UNITED STATES PATENT AND TRADEMARK OFFICE

APPLICATION NO.	FILING DATE	FIRST NAMED INVENTOR	ATTORNEY DOCKET NO.	CONFIRMATION NO.
10/643,055	08/18/2003	Thomas K. Reusche	14809US02	3111
23446	7590	01/31/2006	EXAMINER	
MCANDREWS HELD & MALLOY, LTD 500 WEST MADISON STREET SUITE 3400 CHICAGO, IL 60661			NGUYEN, TRINH T	
			ART UNIT	PAPER NUMBER
			3644

Office Action Summary	Application No.	Applicant(s)	
	10/643,055	REUSCHE ET AL.	
	Examiner	Art Unit	
	Trinh T. Nguyen	3644

DETAILED ACTION

Fig. 1

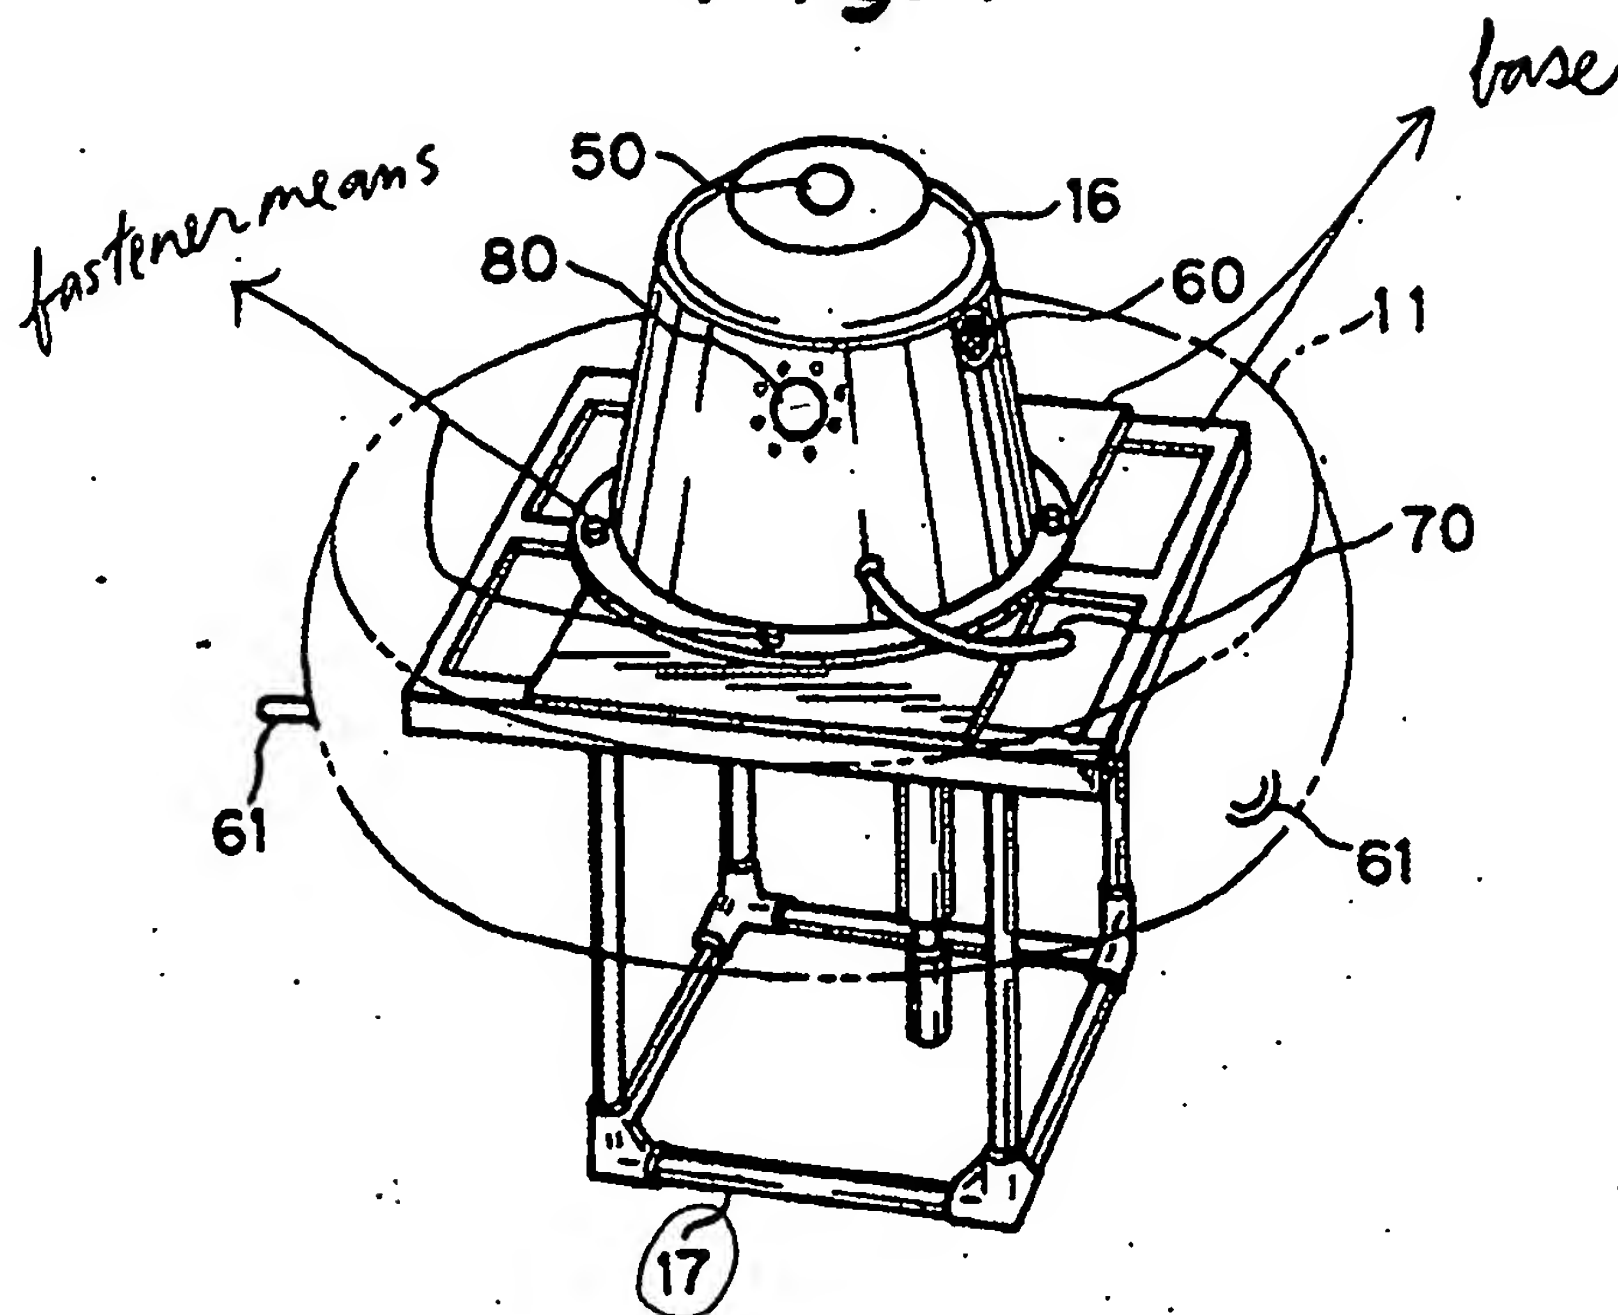
11. Applicant further argues that Kajisono does not teach a base removable interconnected to a cover, the Examiner disagrees. As shown in Figure 1, it is inherently that cover (16) is removably interconnected to base (10) due to those fastener means (which locates around the base of the cover, see Figure 1 attached at the end of this Office Action for further explanation) for connecting the cover to the base.

Fig. 7

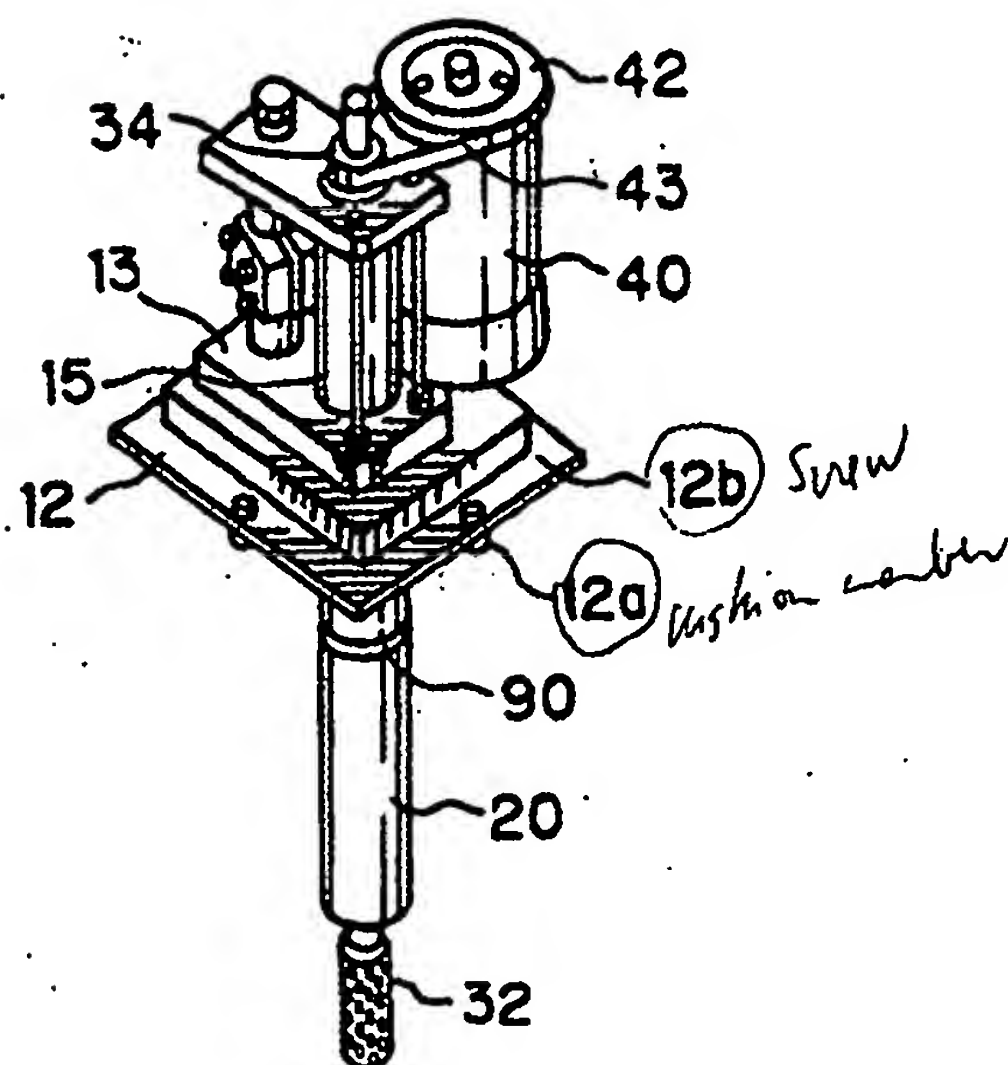
an agitator operatively connected to a motor (40) housed within said main body, said agitator connected to a distal end of a drive shaft (30) that extends outwardly from said main body, said agitator comprising at least one agitation member outwardly extending from a lateral surface of said distal end of said drive shaft (note that in lines 40-50 of col. 4, Kajisono discloses impellers/agitation members outwardly extending from a lateral surface of the distal end of the drive shaft and the motor configured to rotate the agitation member in order to stir water, see Figure 7 attached at the end of

For claims 12 and 25, Kajisono discloses said agitator comprises at least one blade (40-50 of col. 4 and Figure 7) extending from a lateral surface of said drive shaft that is rotatably driven by said motor.

8. Applicant argues that Kajisono does not teach 1) agitator comprising at least one agitation member outwardly extending from a lateral surface of said distal end of said drive shaft" as recited in claim 1, 2) a blade assembly extending outwardly from said drive shaft as recited in claim 14, and 3) an agitator having at least one blade outwardly extending from a lateral surface of said drive shaft as recited in claim 27, the Examiner disagrees. As shown in lines 40-50 of col. 4 and Figure 7, Kajisono discloses that "it is preferable to provide impellers" or agitation members or blade assembly outwardly extending from a lateral surface of the distal end of the drive shaft (30, see Figure 7 attached at the end of this Office Action for further explanation).
